NEENAH PLAN COMMISSION

RE: Site Plan Review – 601 S Commercial Street – Building Expansion

RE: Site Plan #13-25 - 601 S Commercial St - Galloway Co Site Plan - Major Review () Status Approved

RE: Site Plan #14-25 - 1080 Breezewood Lane - Fire Station Site Plan - Major Review () Status Approved

CIVIL SITE PLAN

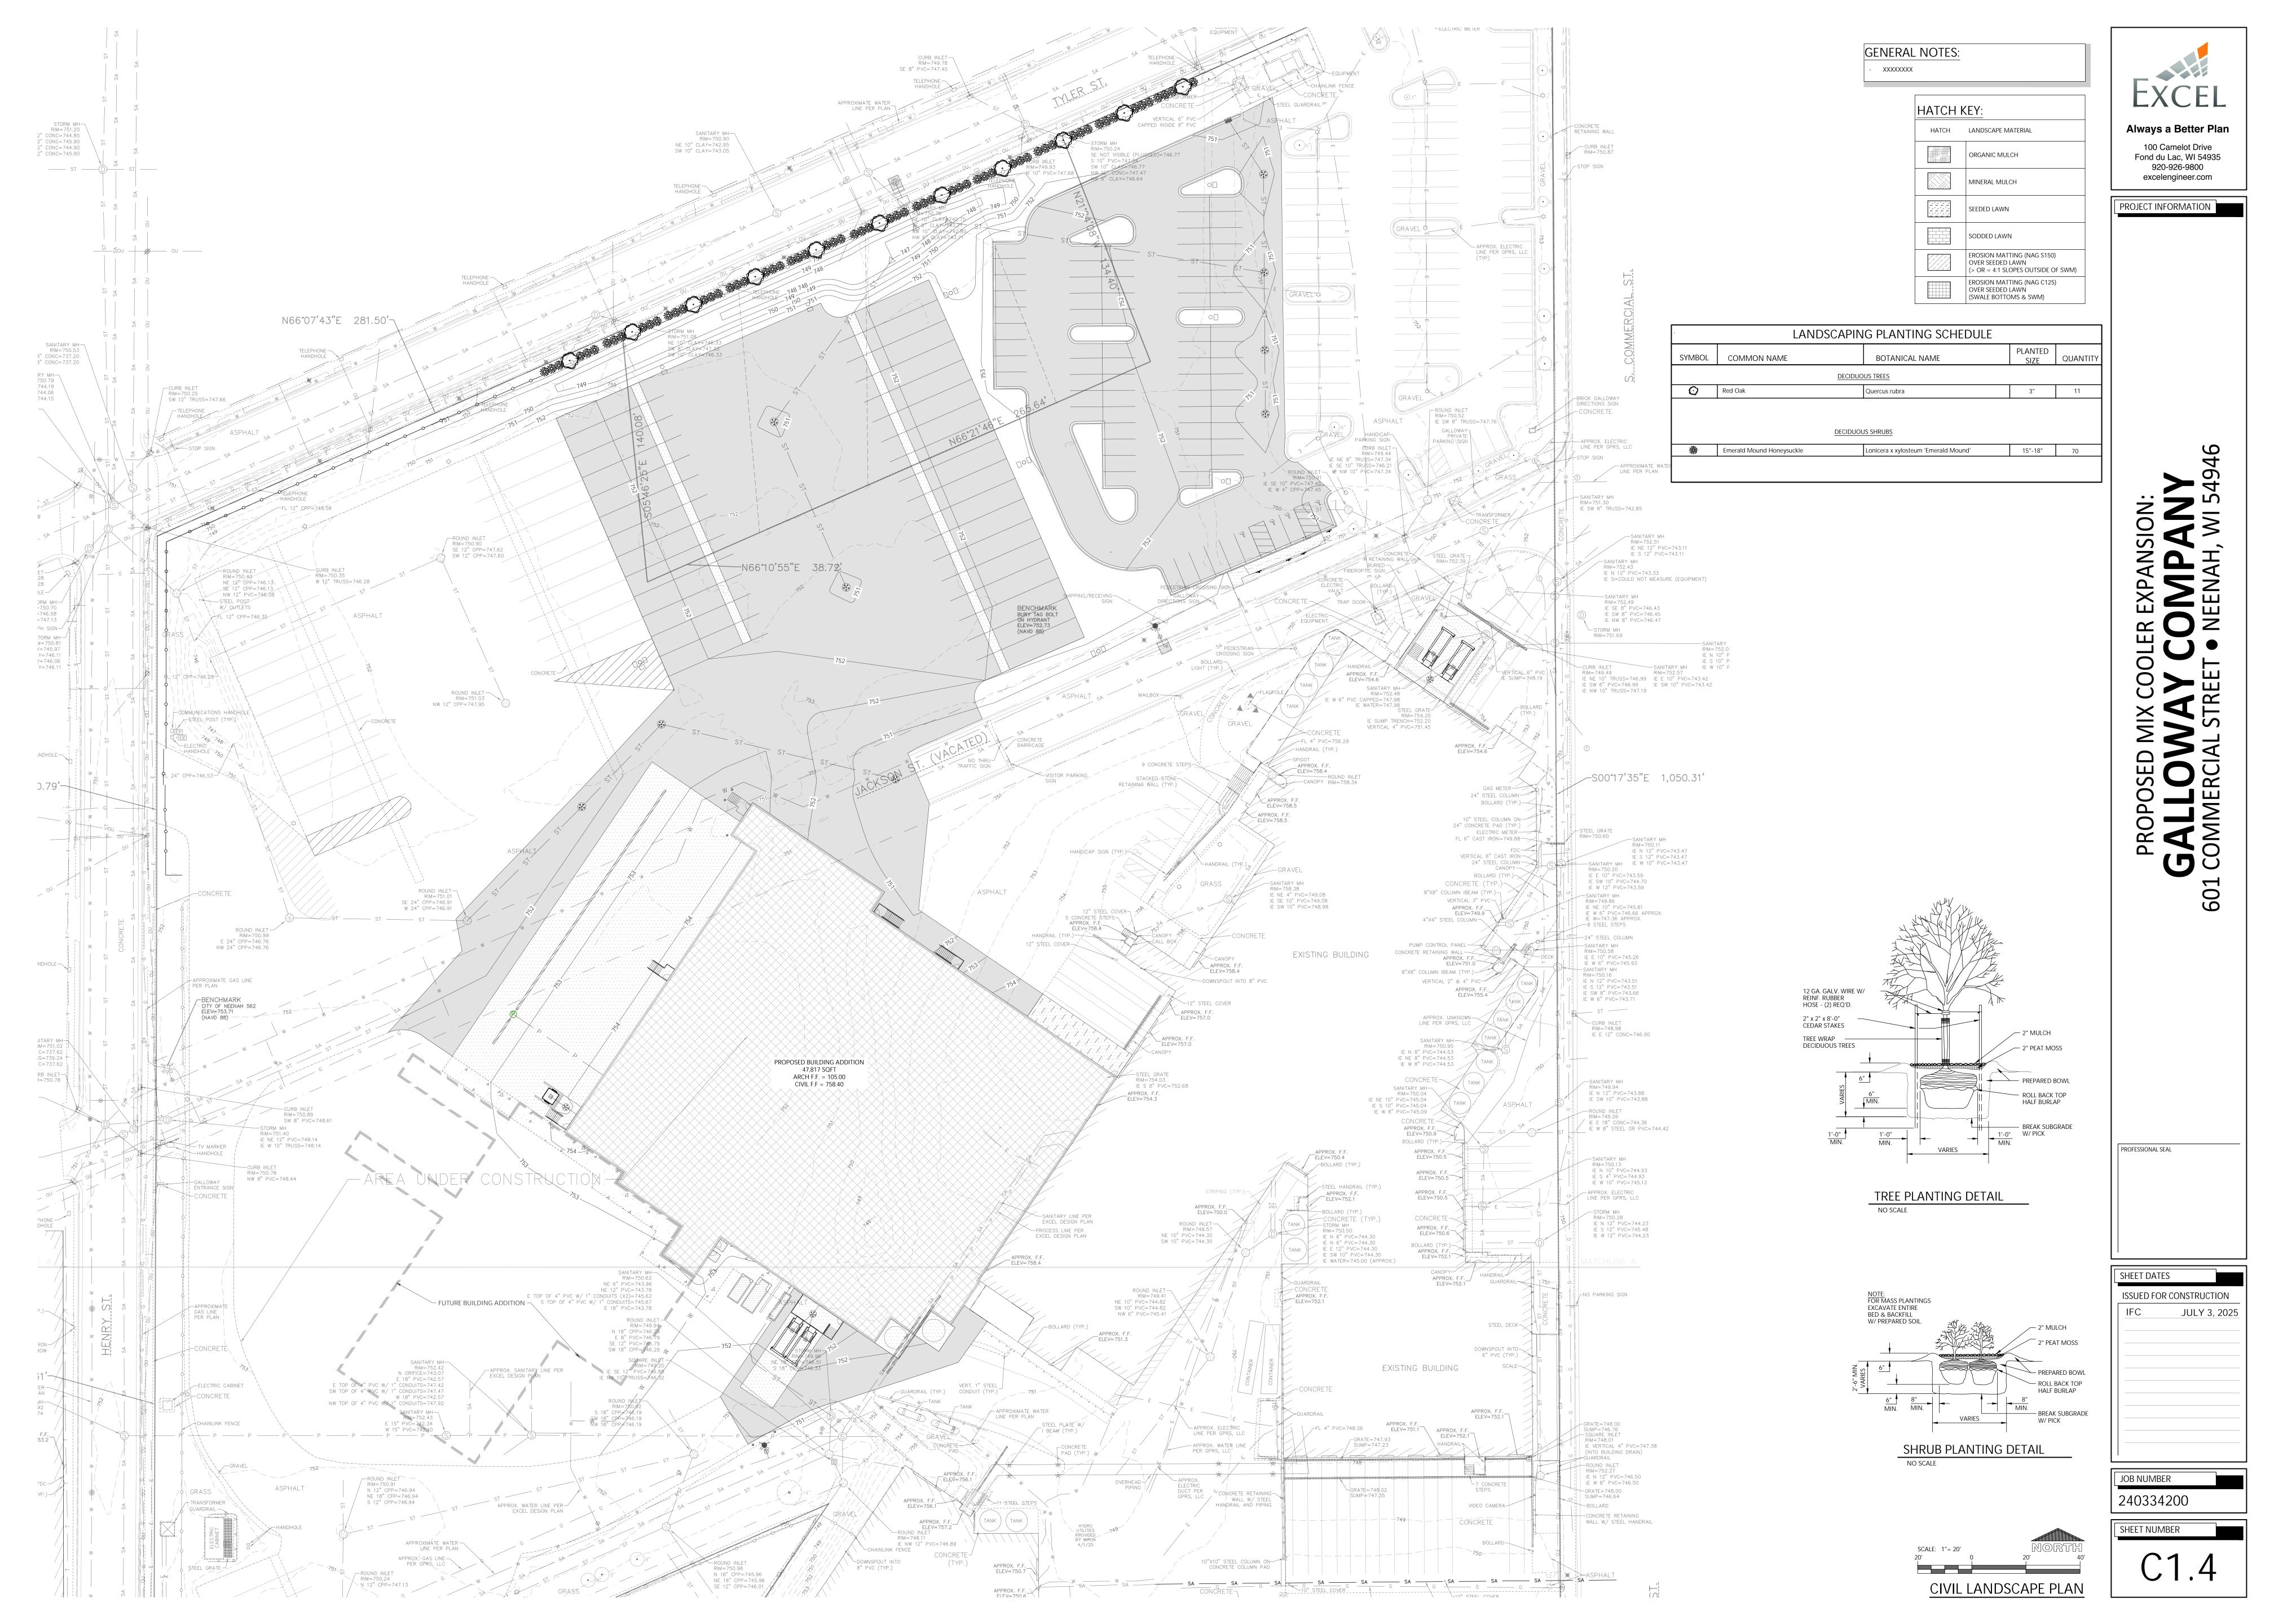
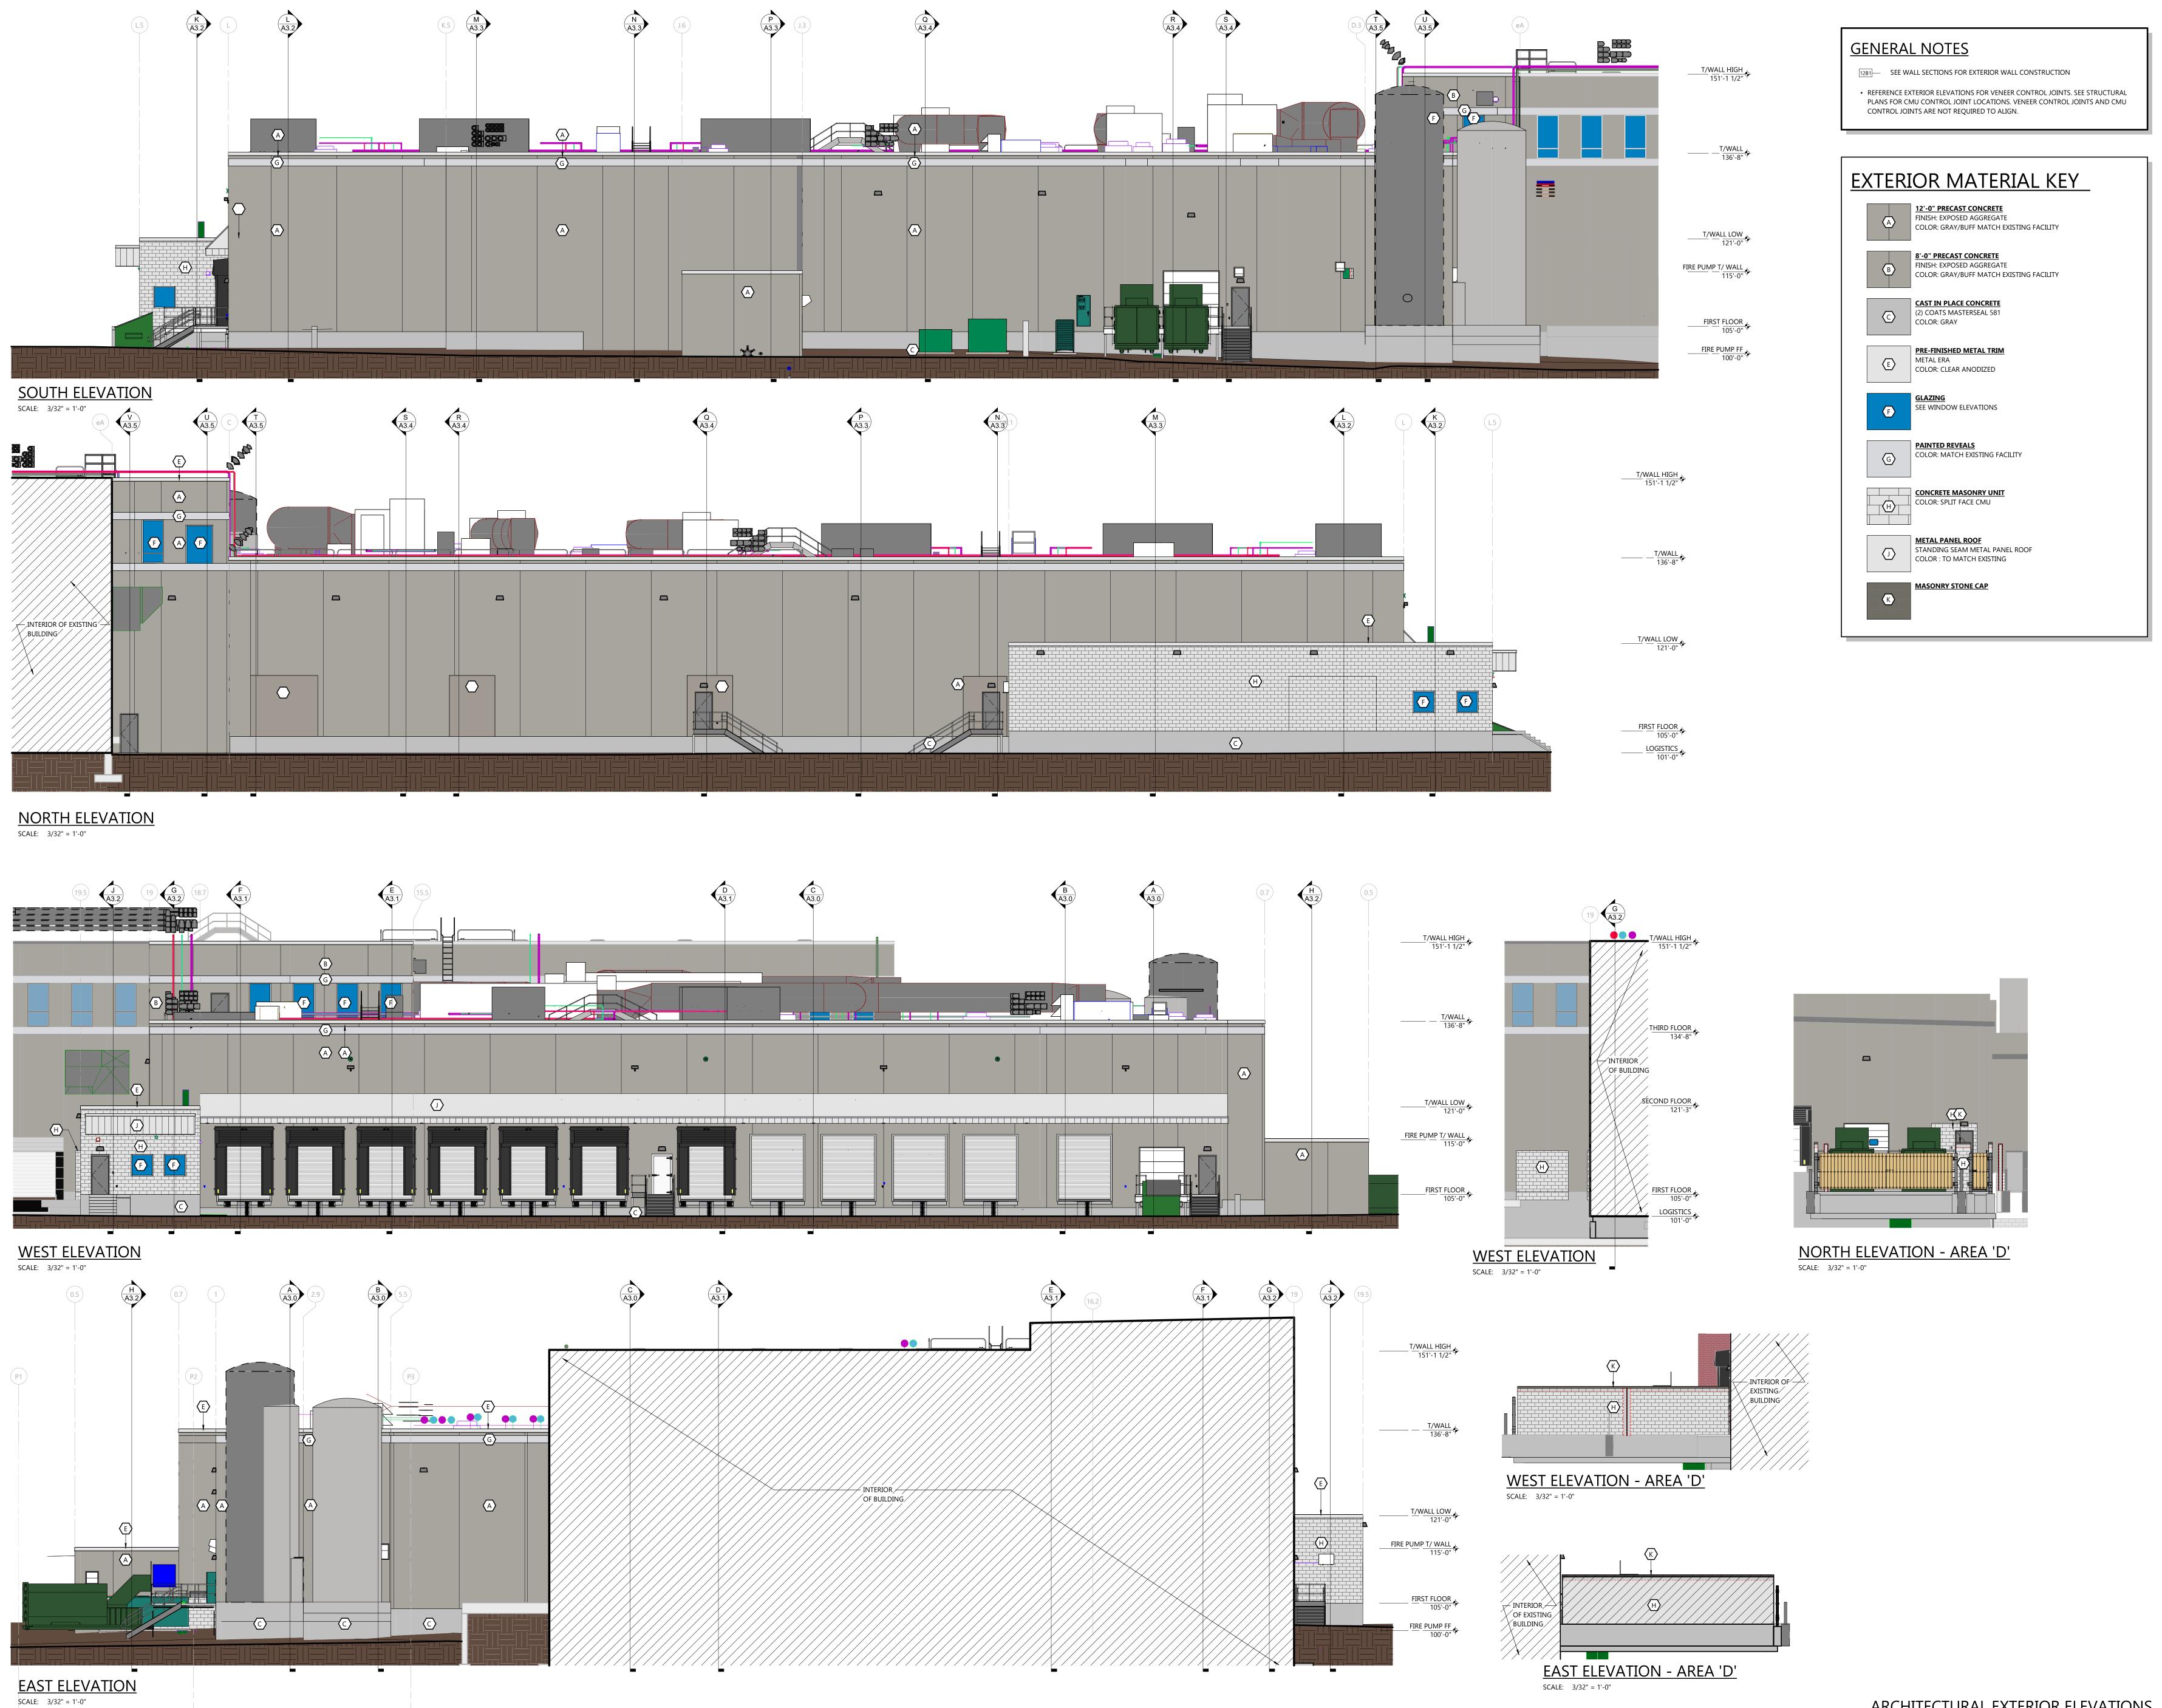
- 2. Submit a landscape plan showing the proposed street tree plantings within the parking lot islands.
- 3. Consider installing a sight tight fence or a row of evergreen trees along Tyler Street adjacent to the trailer parking areas in-lieu of a chainlink fence to provide additional buffering from residnetial properties along Tyler St.

- 4. Submit an outdoor lighting plan showing ligting levels and information on lighting pole heights and fixture information. Full-cut-off fixtures are required.
